Access Compliance Report

Public Rights-of-Way

Intersection ID: 18963	Main Street: GROVER_RD	Cross Street: SOUTH_BV	Location: SW
ADA ID: B8E5CA5A9A35	Ramp Type: Perp	Initial Pass/Fail: Fail	Overall Compliance: No
Severity Score: 13.75			
Codes/Mitigation Info/Possible Solution		Field Measurements/Component Compliance

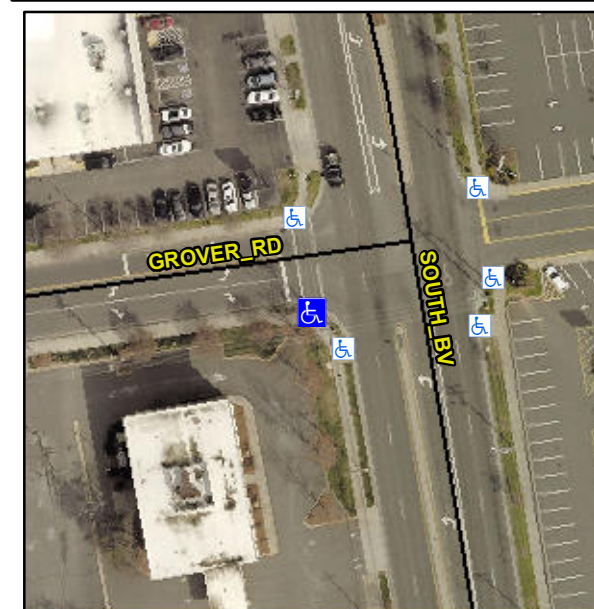
Not Found, R304.2.2, R304.5.3

Compliance	Description	Data	Compliance	Description	Data
N/A	Ramp Length (in)	47.5	No	Ramp Slope (%)	10.0
Yes	Ramp Width (in)	70.0	No	Ramp XSlope (%)	3.3
N/A	Flare Type LT	N/A	N/A	Flare Type RT	N/A
N/A	Flare Slope LT (%)	N/A	N/A	Flare Slope RT (%)	N/A
N/A	Flare Traversable LT?	N/A	N/A	Flare Traversable RT?	N/A
N/A	Landing Length (in)	N/A	N/A	DWS Provided?	N/A
N/A	Landing Width (in)	N/A	N/A	DWS Contrast?	N/A
N/A	Landing Slope (%)	N/A	N/A	DWS Length (in)	N/A
N/A	Landing X Slope (%)	N/A	N/A	DWS Full Width?	N/A
N/A	Landing Curb? (Y/N)	N/A	N/A	DWS Offset (in)	N/A
N/A	Shared Landing?	N/A			
N/A	Gutter Ponding?	N/A	N/A	Gutter Slope (%)	N/A
N/A	Gutter Lip Ht (in)	N/A	N/A	Gutter X Slope (%)	N/A
N/A	Painted X Walk1?	Yes	N/A	Painted X Walk2?	N/A
	X Walk 1 Direction	To N		X Walk 2 Direction	N/A
N/A	X Walk 1 Width (in)	110.0	N/A	X Walk 2 Width (in)	N/A
	X Walk 1 Slope (%)	2.2		X Walk 2 Slope (%)	N/A
	X Walk 1 X Slope (%)	2.8		X Walk 2 X Slope (%)	N/A

Remove & Replace Entire Ramp.
